**Medway Planning & Economic Development Board
Meeting**

Phytopia Public Hearing Continuation
Major Site Plan, Reduced Parking
Special Permit and Groundwater
Protection Special Permit

**Re: Phytopia Inc.
 Major Site Plan Review
 6 Industrial Park Road
 Medway, Massachusetts**

DRAWING: C1.1	12	11	10	9	8	7
				3/7/2022	1/9/2022	10/12/2021
				Town Comments / Peer Review	Town Comments / Peer Review	Town Comments / Peer Review

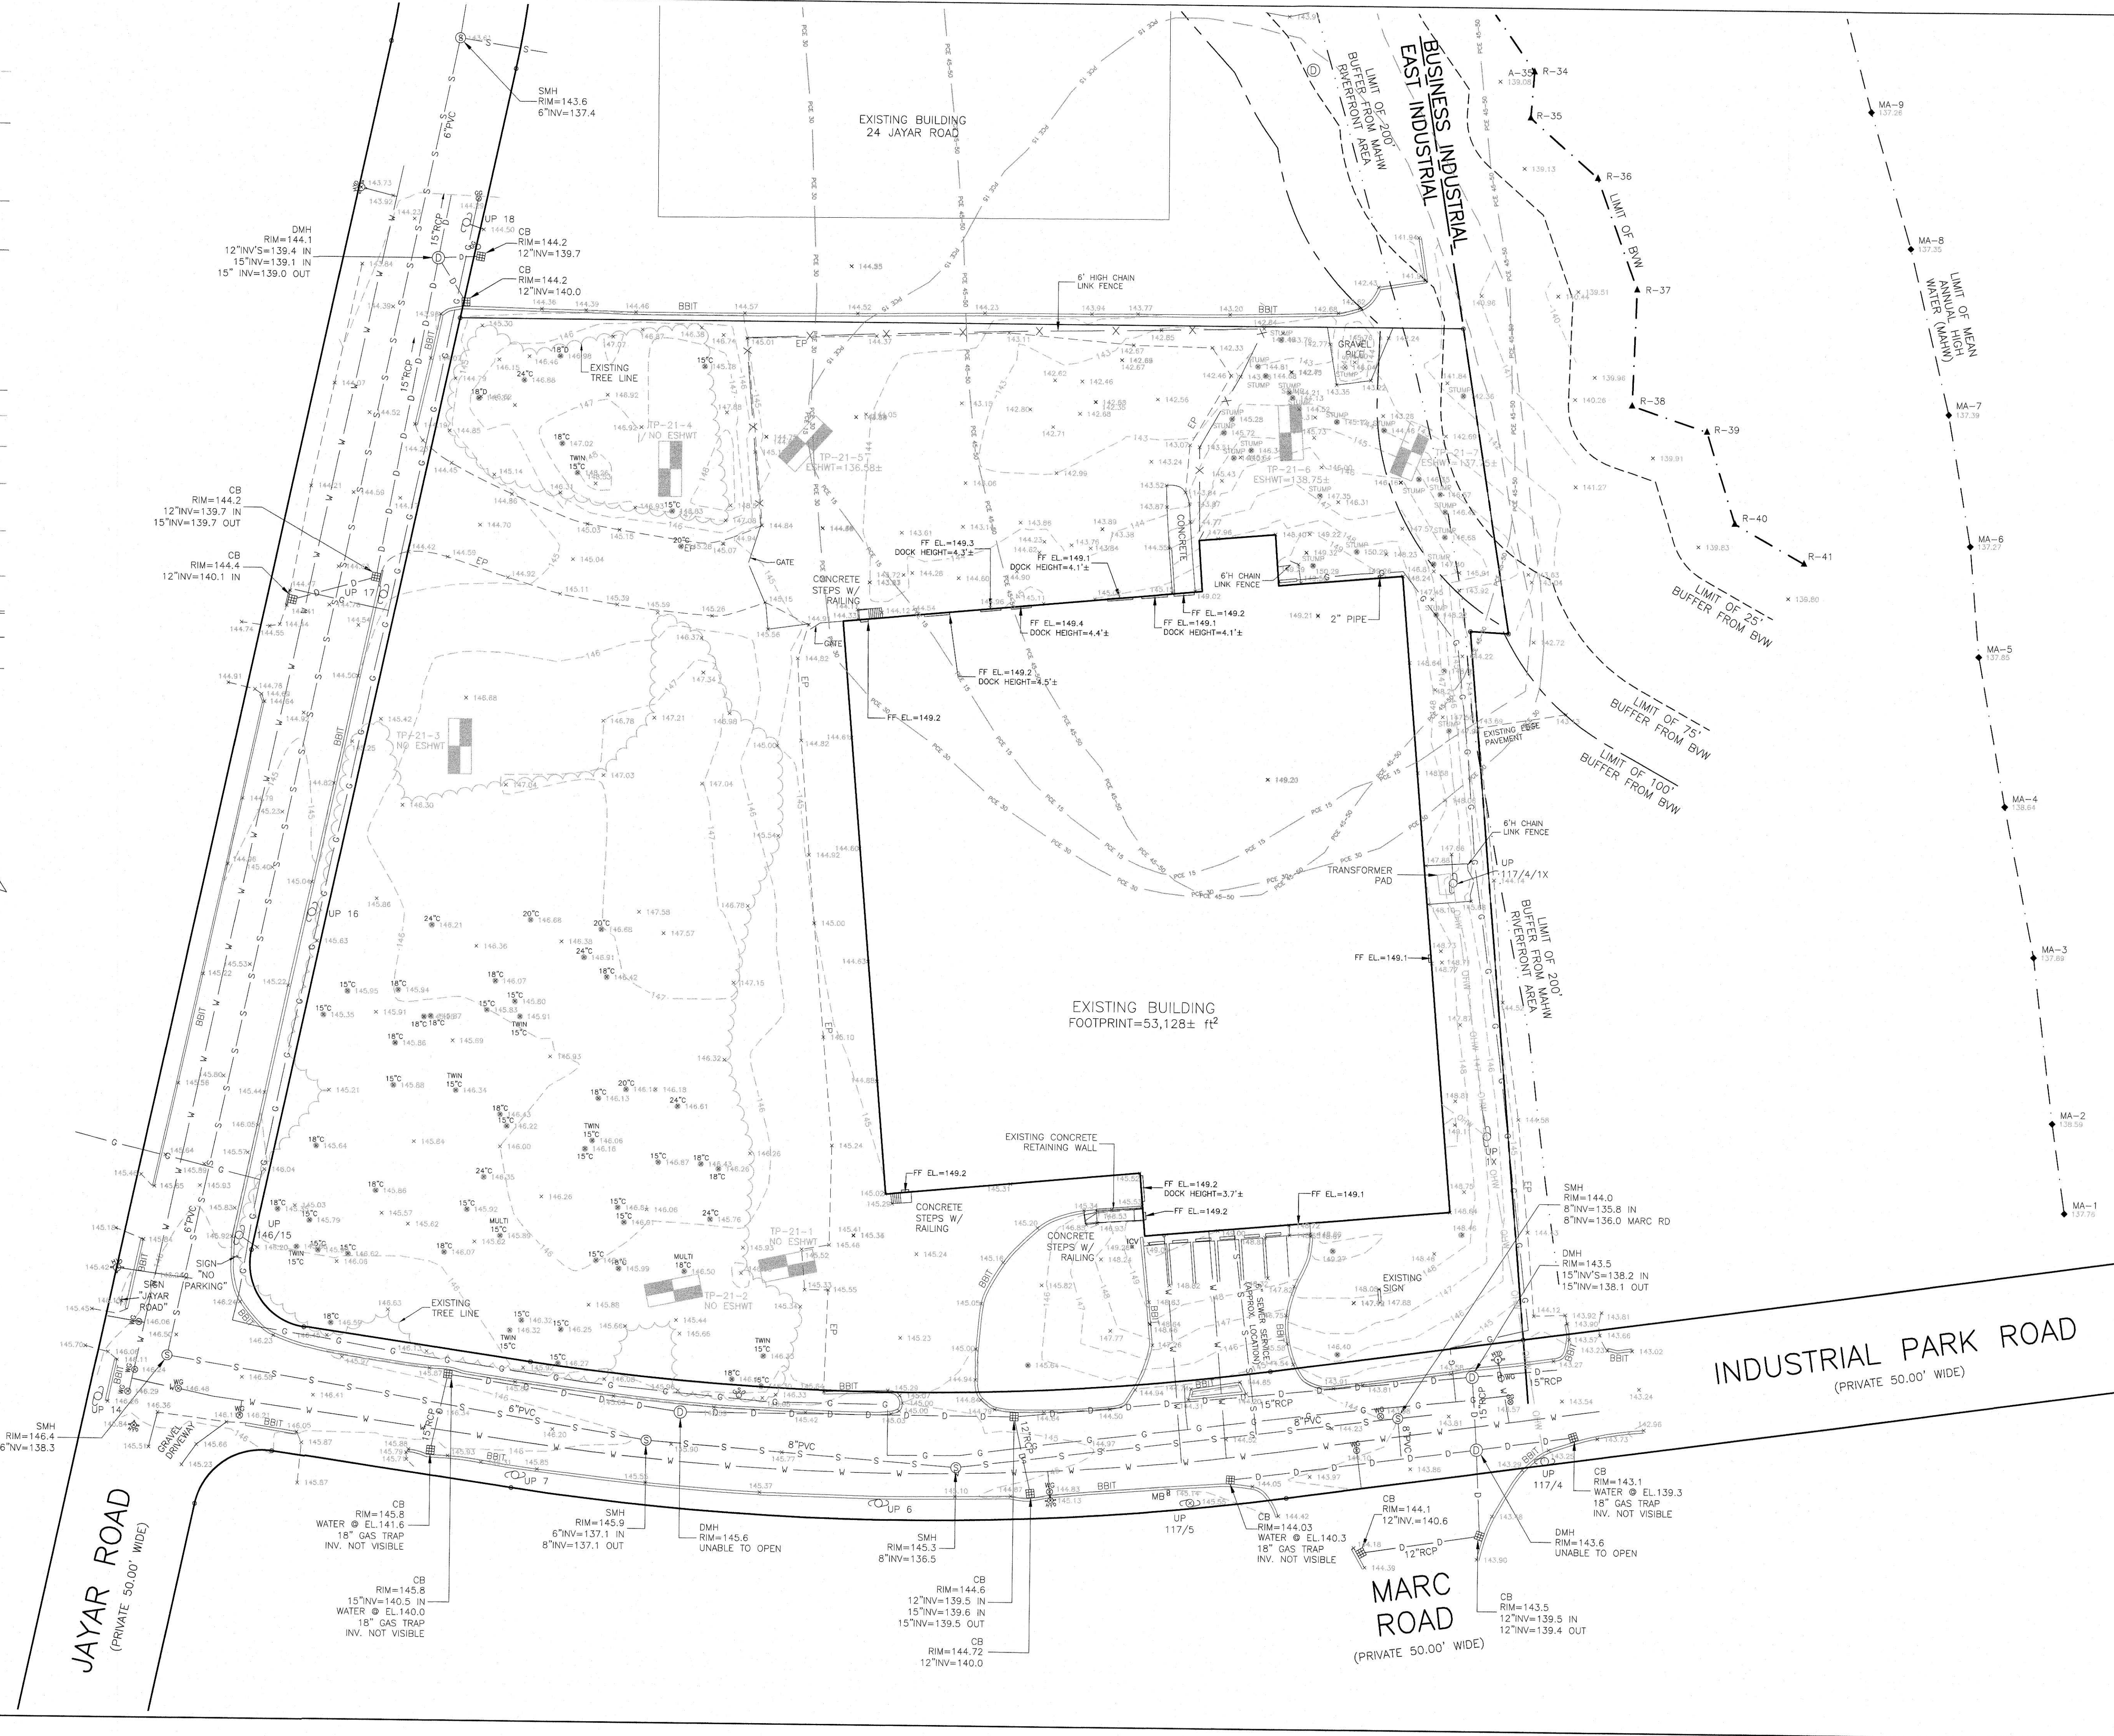
6. Cover sheet has not been provided in the Plans. However, applicable cover sheet information is provided on the Site Context Sheet/Location Plan. A list of requested waivers should be added to the sheet once approved by the Board. (Ch. 200 §204-5.A)

- *WSE 10/12/21 Response: A cover sheet with a list of waivers has been provided, see sheet 1 of 10.*
 - **TT 10/27/21 Update: The list of requested waivers has not been included on the Cover Sheet.**

- *WSE 4/12/22 Response: The list of requested waivers has been added to Sheet 1, the Cover Sheet.*
 - **TT 4/22/22 Update: In our opinion, this comment is resolved.**

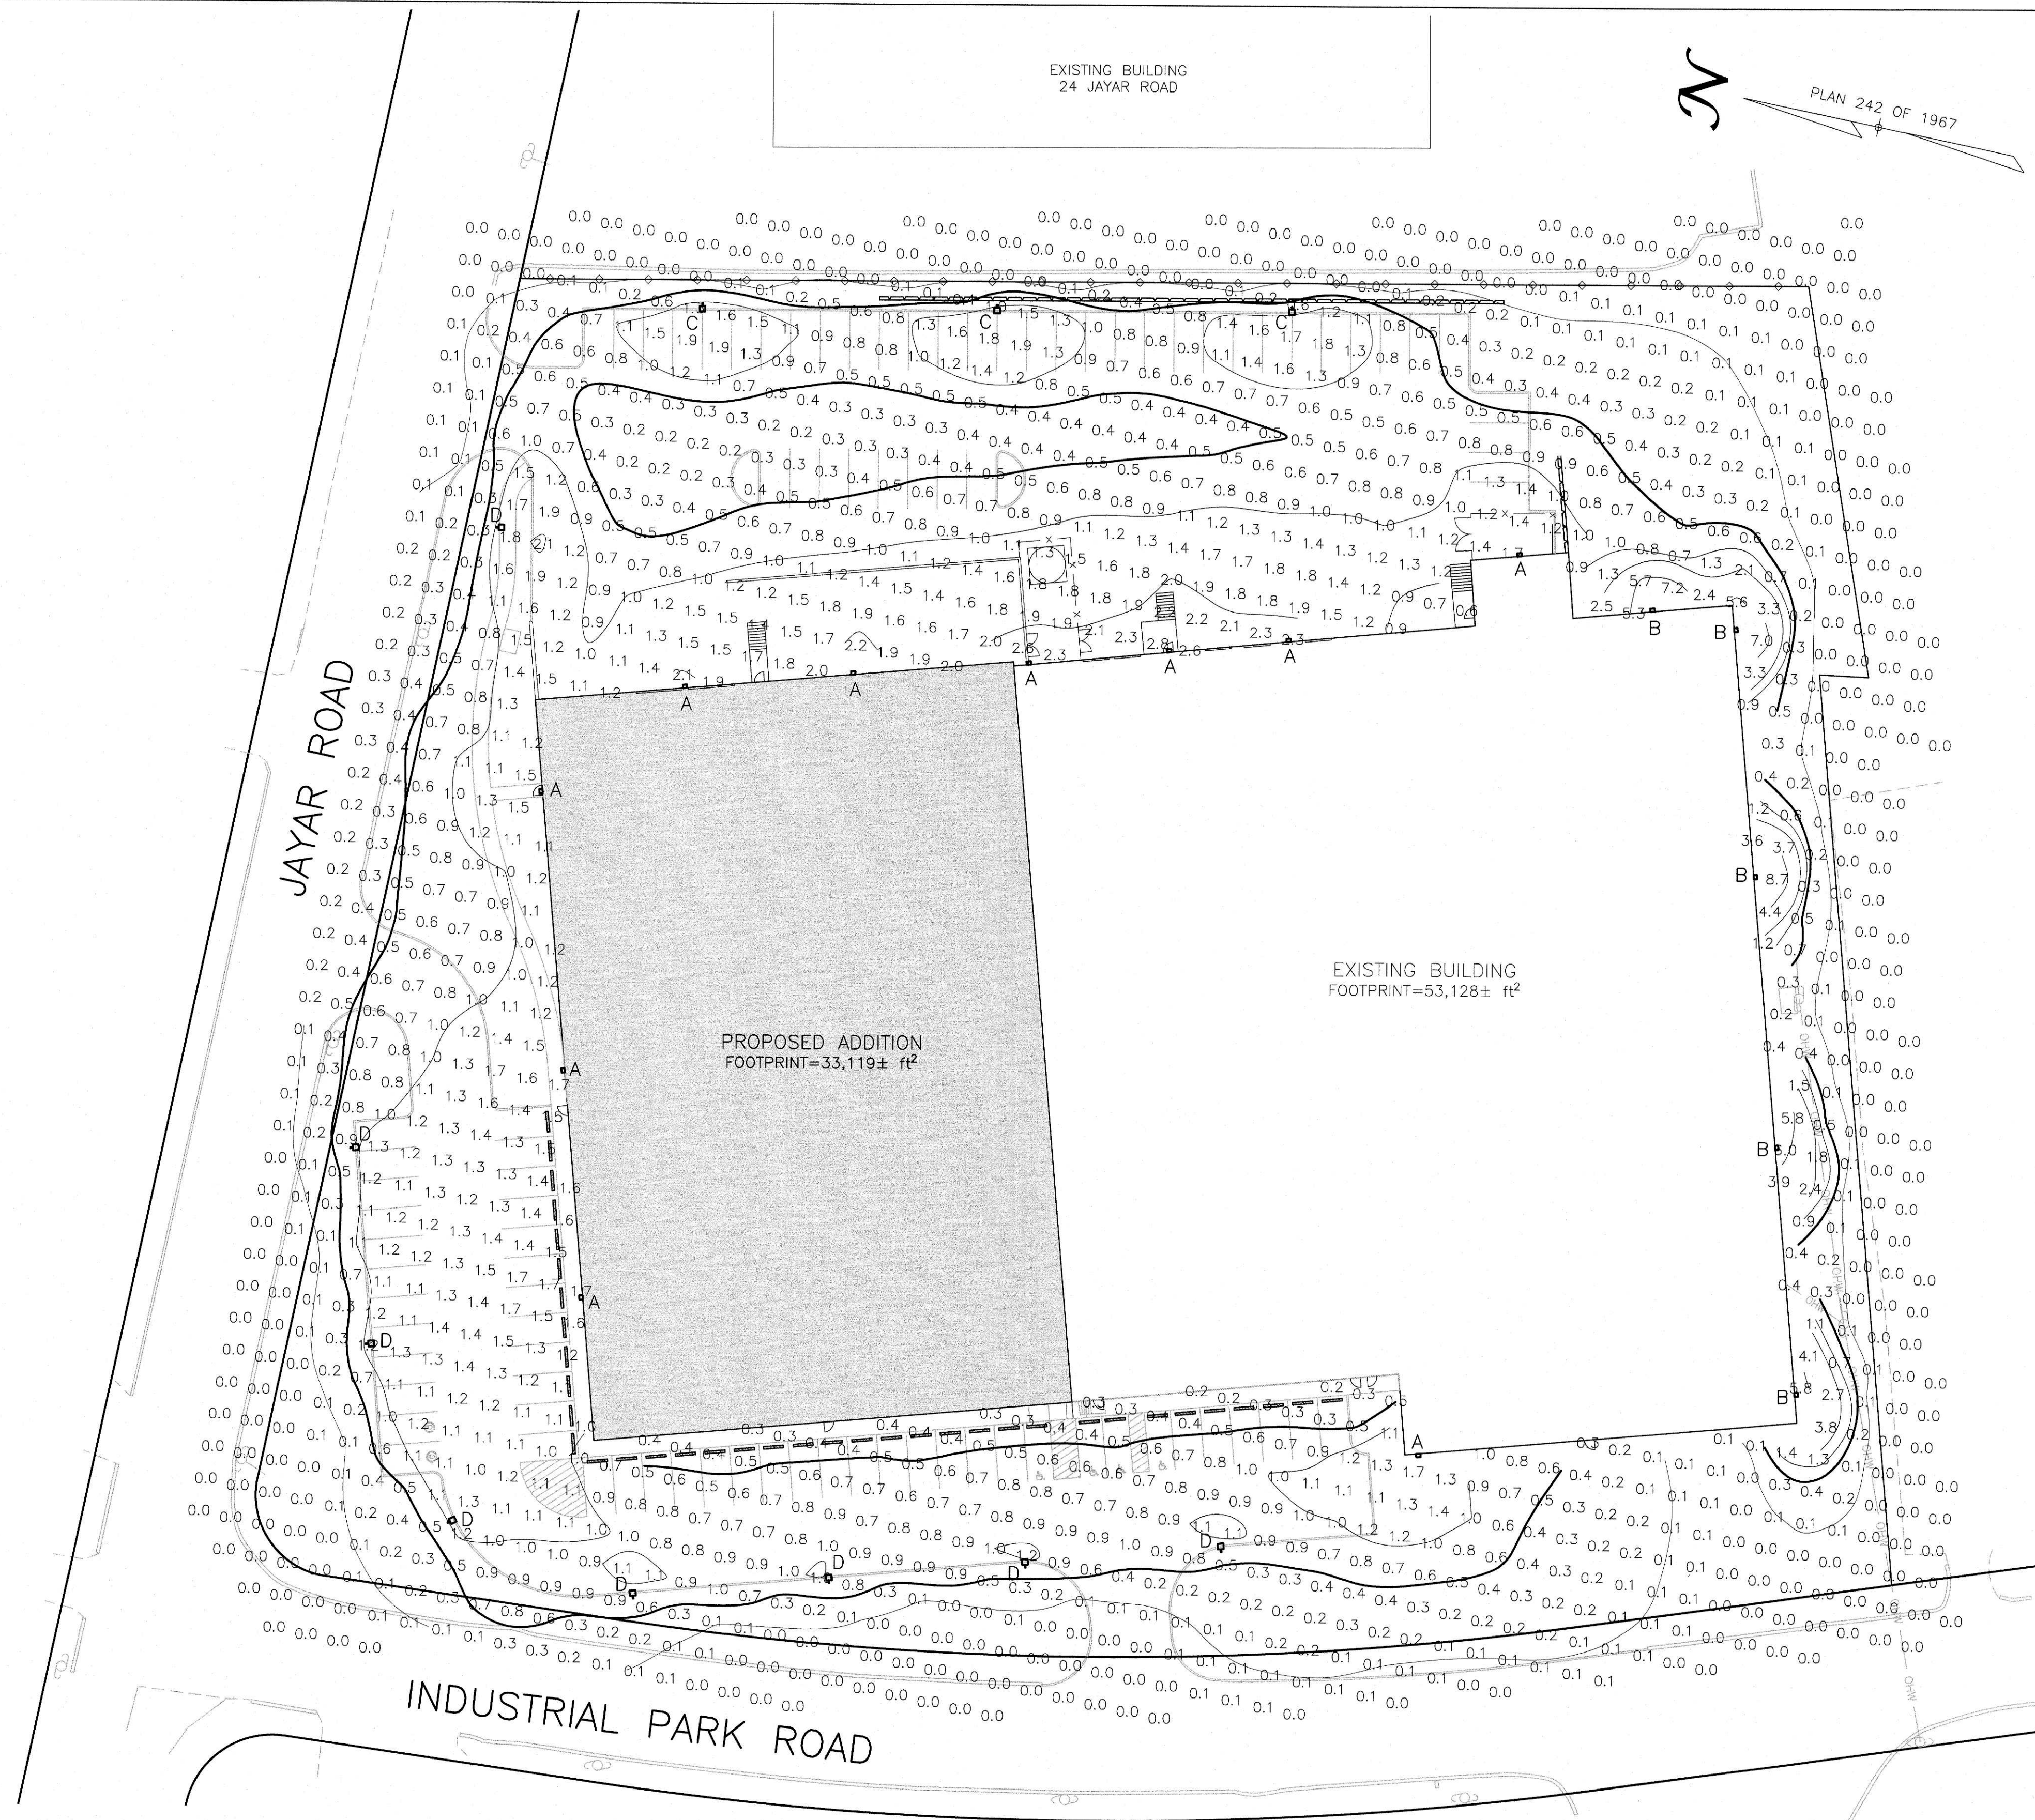
27. The Photometric Plan does not show any light levels beyond the property lines. We anticipate light trespass along the northwestern and northeastern and eastern property lines. (Ch. 200 §207-18)

- *WSE 10/12/21 Response: The Photometric Plan has been revised to show light levels beyond the property line.*
 - **TT 10/27/21 Update: Light trespass occurs along each of the property lines to multiple abutters.**

- *WSE 4/12/22 Response: The lighting design has been revised to eliminate light trespass on abutting properties. Please see revised Photometric Plan.*
